FROM: Pennsylvania Power & Light Co. Allentown, Pa N.W. Curtis		DATE OF DOC not dated	DATE REC'D 10-15-75	LTR XXXX	TWX	RPT	OTHER
TO: Mr. W.H. Regan, Jr		ORIG 1-signed	CC	OTHER	SENT NRC PDR SENT LOCAL PDR		
CLASS	UNCLASS XXXX	PROP INFO	INPUT	NO CYS REC'D 1	DOCKET NO: <u>60-387</u> and 388		
DESCRIPTION: ltr re their 9-29-75 telephone conversation furn changes and their construction schedule for Susquehanna Steam Electric Station trans the following				ENCLOSURES: Attach Drawings Fig. 1, 2, and 3 ACKNOWLEDGED DO NOT REMOVE			
PLANT NAME: Susquehanna 1& 2

SUSQUEHANNA STEAM ELECTRIC STATION
TRANSMISSION LINE CHANGES
ER 100450 FILE 991-2
PLA-86

Docket Nos. 50-387 &
50-388

FIGURE 1

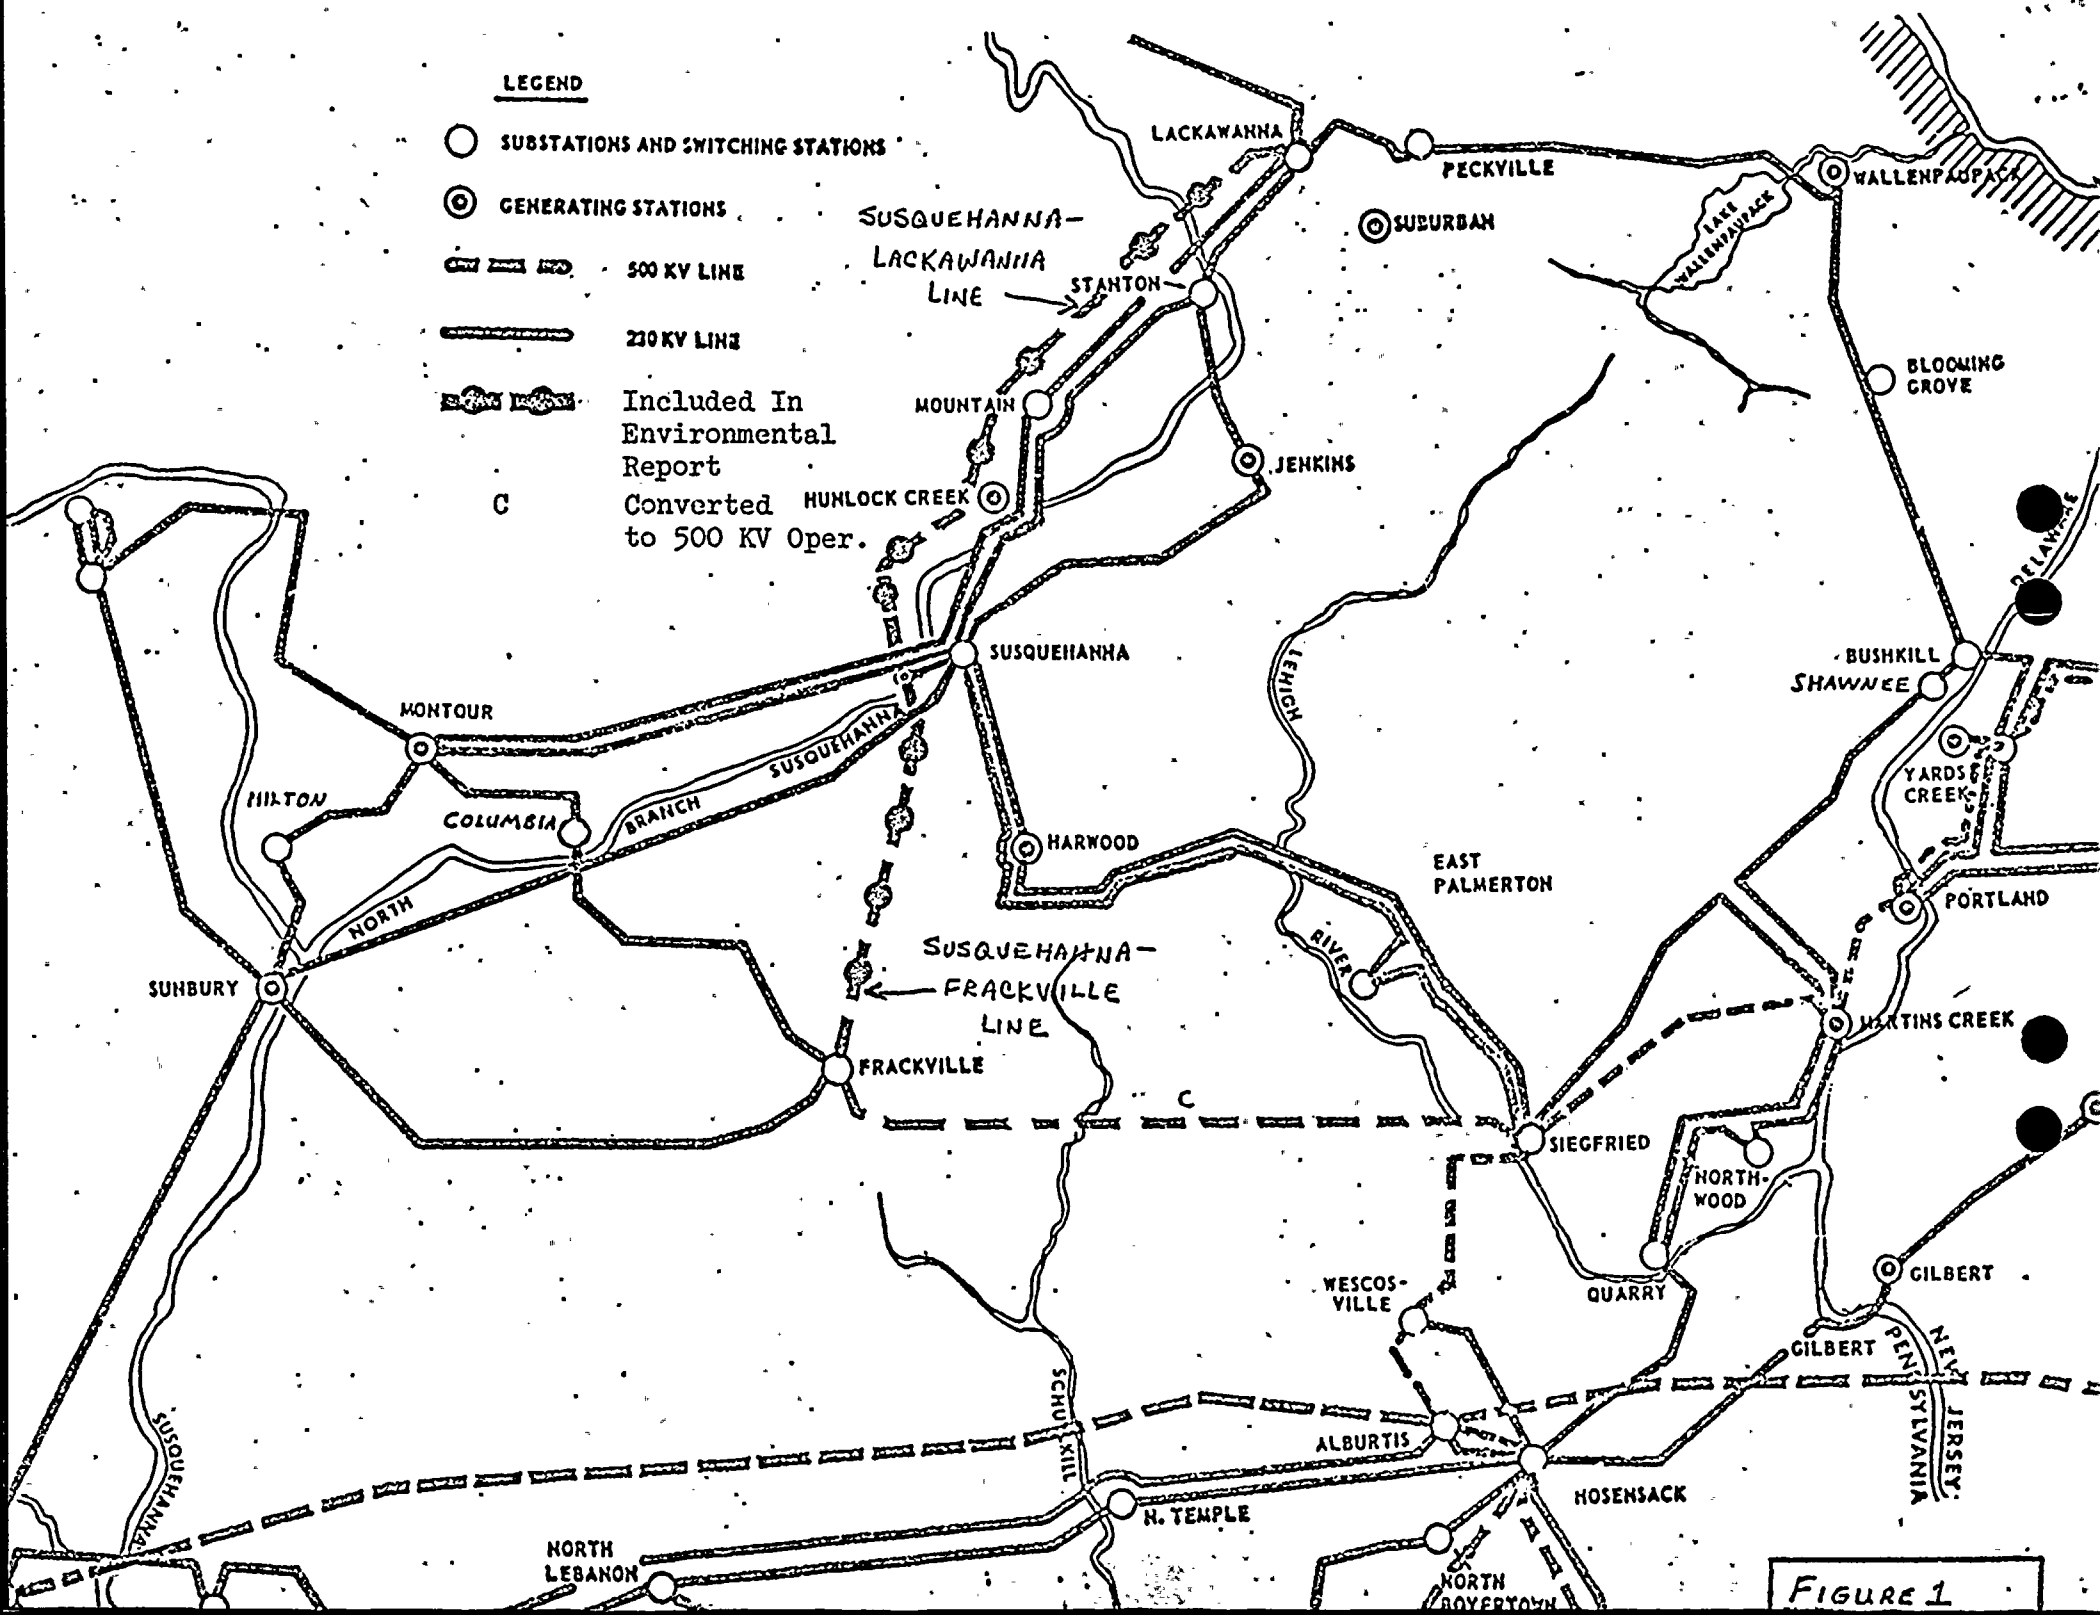
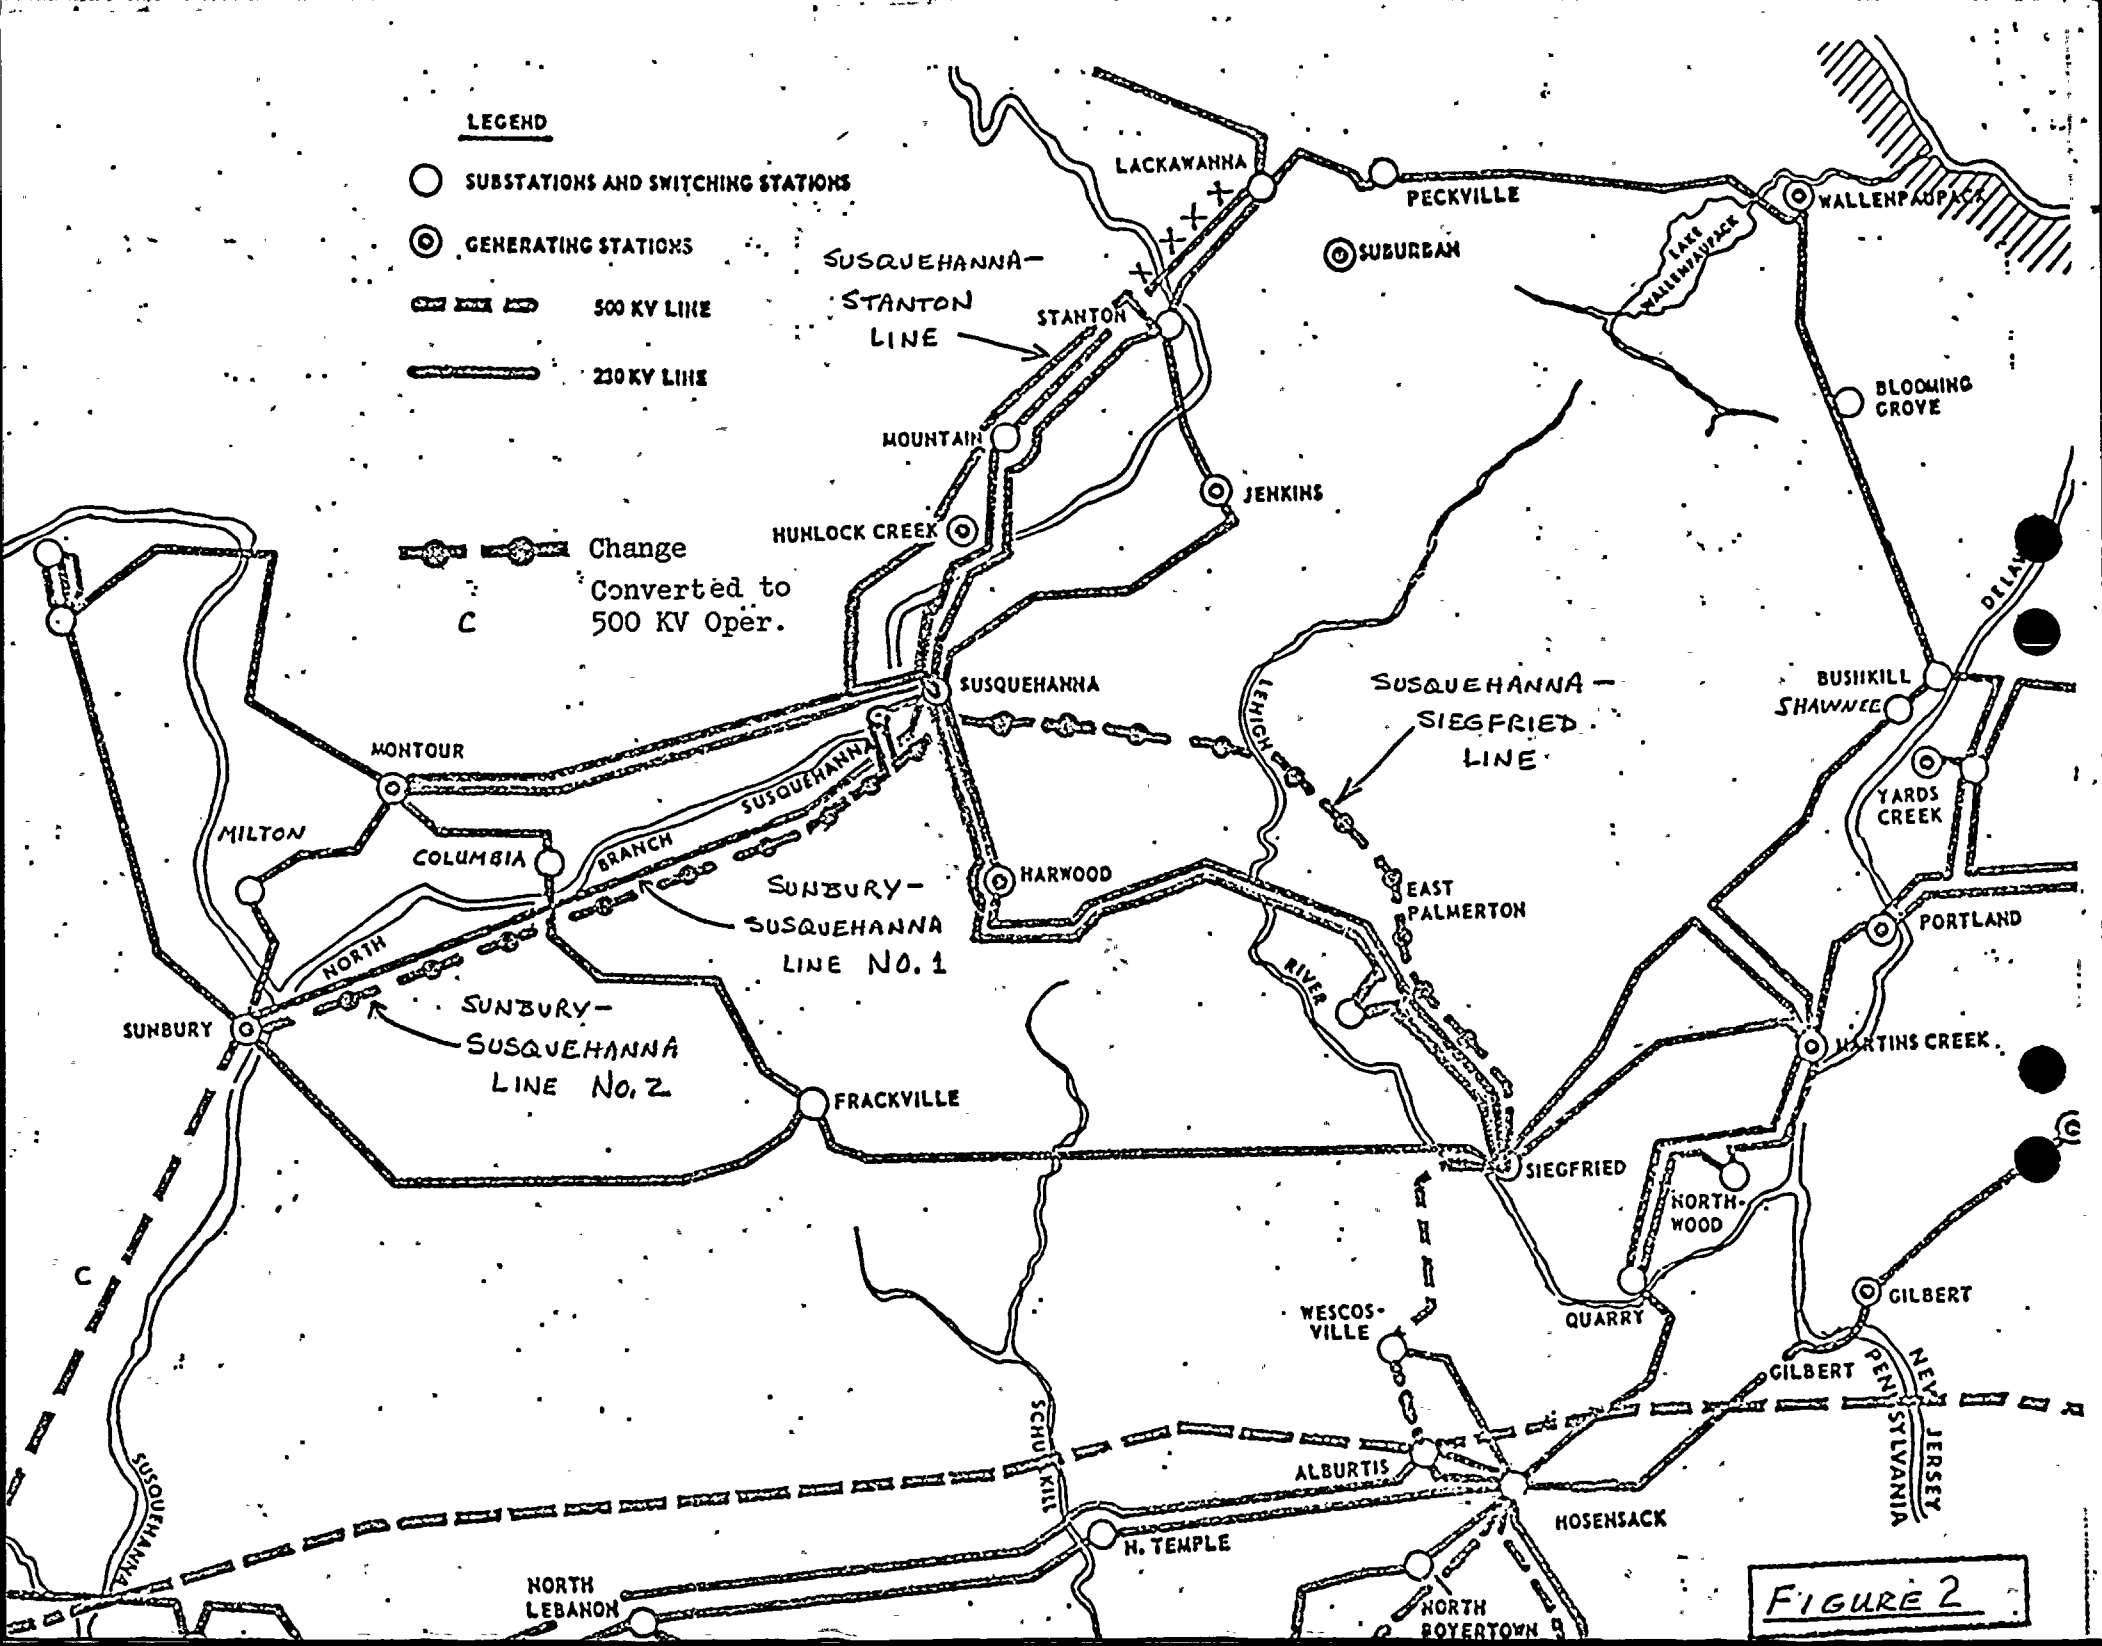
Major changes by other companies in the planned development of the Pennsylvania-New Jersey-Maryland bulk power system remote from SSES have required a change in the long-run transmission lines for SSES. These changes are required to provide adequate stability margin and transmission capacity in the northern portion of the PP&L system to accommodate the installation of SSES. Figure 1 shows the transmission lines as described in the Environmental Report - Construction Permit Stage (ER); Figure 2 shows the new arrangement. The changes, by segment, from the original arrangement as described in the ER are as follows:

1. The Susquehanna-Frackville 500 Kv line has been deleted.
2. The Susquehanna-Lackawanna 500 Kv line has been shortened by 11 miles and terminates at Stanton. The remaining portion of that line is identical with that described in the ER. It has been redesignated the Susquehanna-Stanton line and will be operated at 230 Kv. The line will originate from the existing Susquehanna 230 kv switchyard which is located about 1.5 miles east of SSES. The Susquehanna-Stanton line will be constructed with tubular steel H-Frame structures rather than the conventional lattice steel towers described in the ER. The H-Frame structures are, however, described in the ER for use near the plant site.

3. The Sunbury-Susquehanna No. 2 500 Kv line will be added. This line will be built on previously secured right-of-way adjacent to the existing Sunbury-Susquehanna No. 1 230 Kv line. Tower design has not been finalized at this time, but it will be either the steel lattice towers or the H-frame tubular structures.

4. A Susquehanna-Siegfried 500 Kv line will be added. A portion of this line will parallel existing transmission lines. The bulk of the remaining right-of-way was previously secured. The Susquehanna-Siegfried line will be connected to the existing Siegfried-Wescosville line, which is currently being upgraded from 230 Kv to 500 Kv (for other than SSES requirements), and will by-pass Siegfried Substation. H-Frame structures will be used for the Susquehanna-Siegfried line.

FIGURE 3

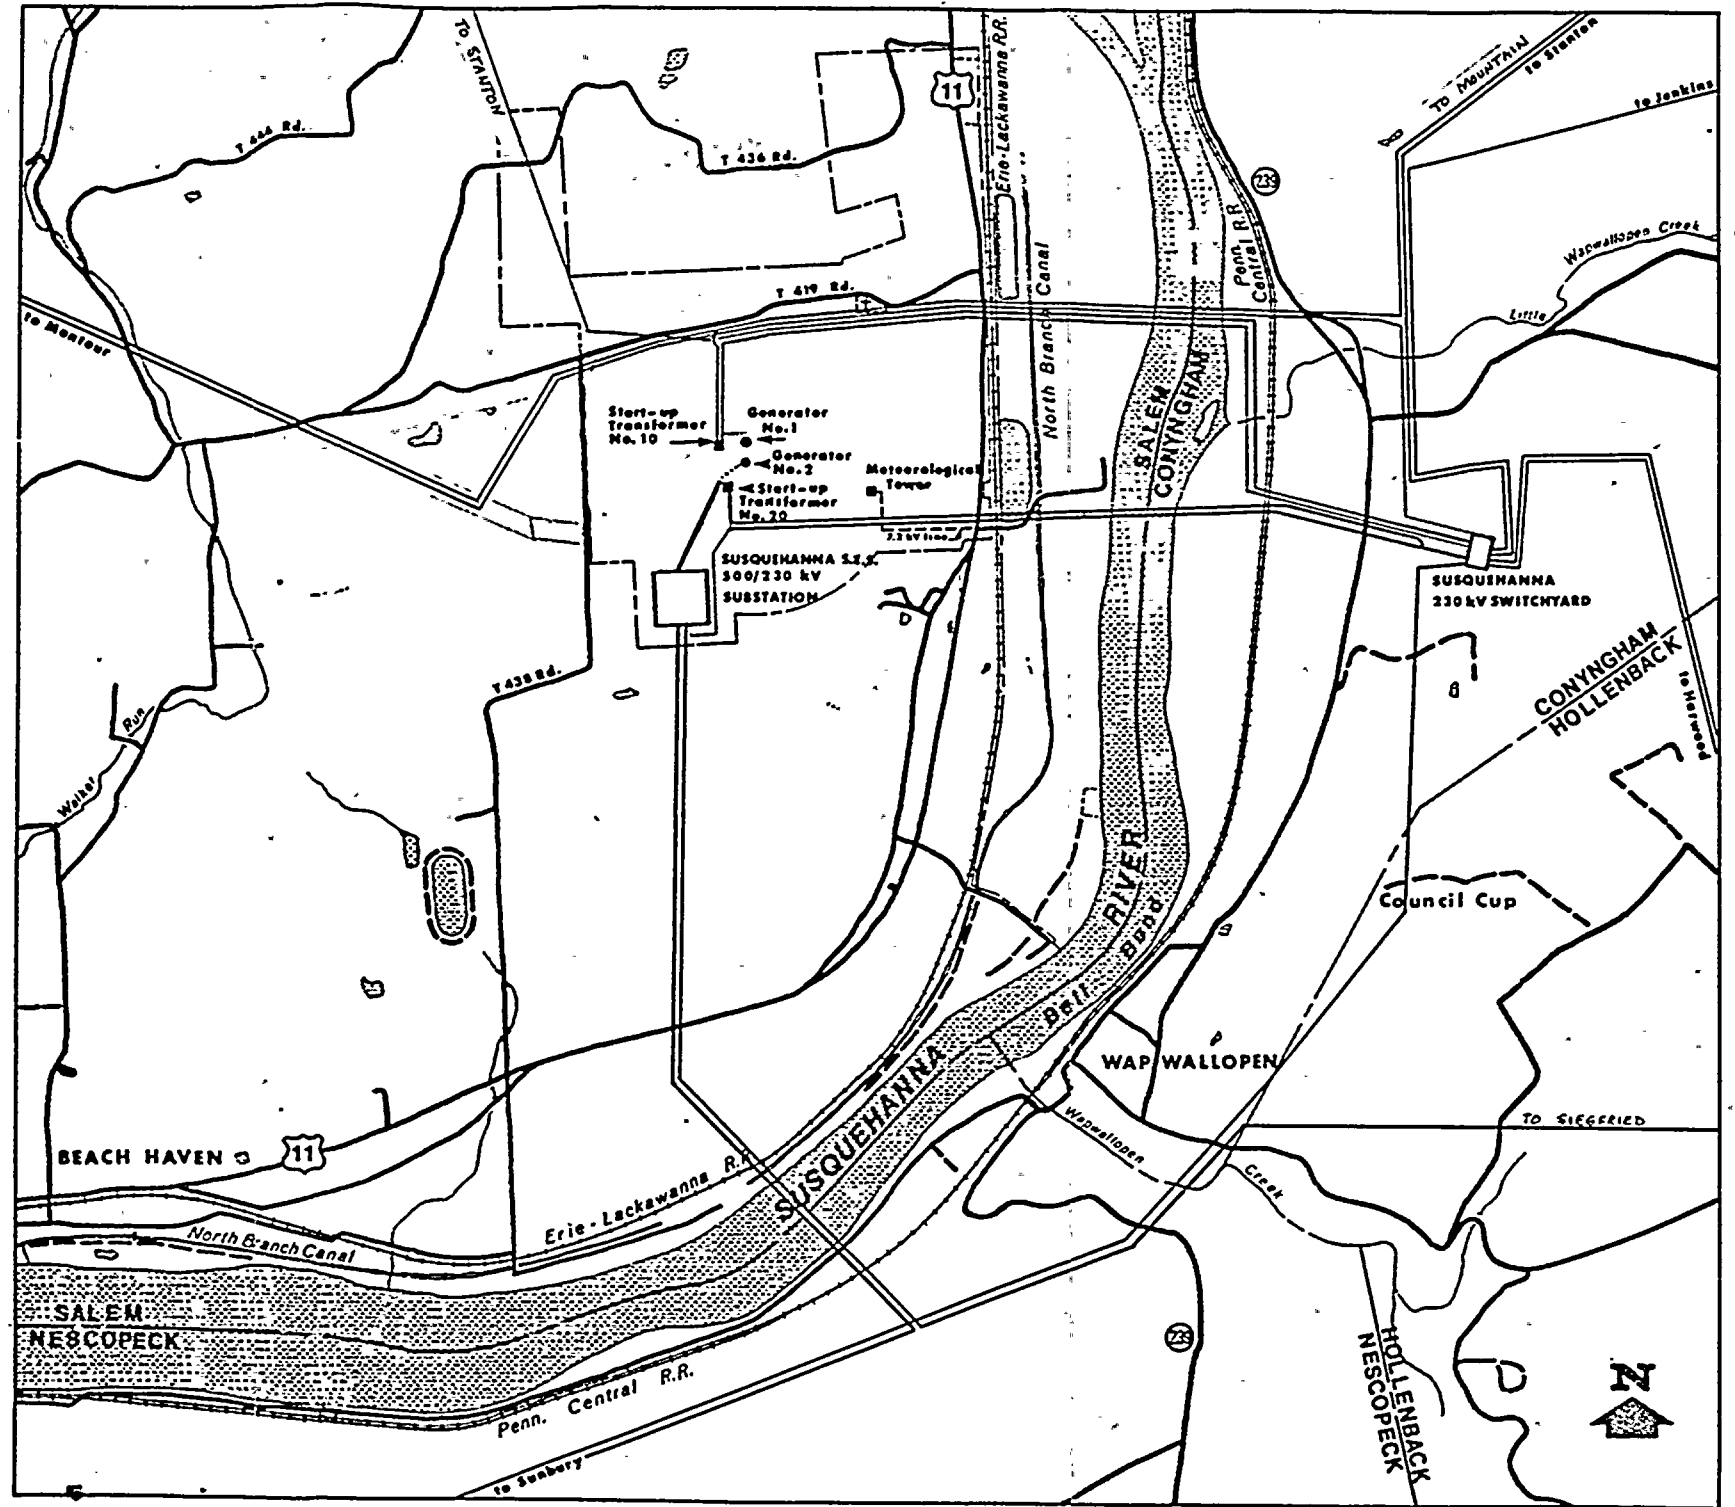
5. Figure 3 shows minor routing changes which will be made in the short-run line arrangement in the immediate vicinity of the plant. The original arrangement is shown in the ER on Figure 3.2.1.
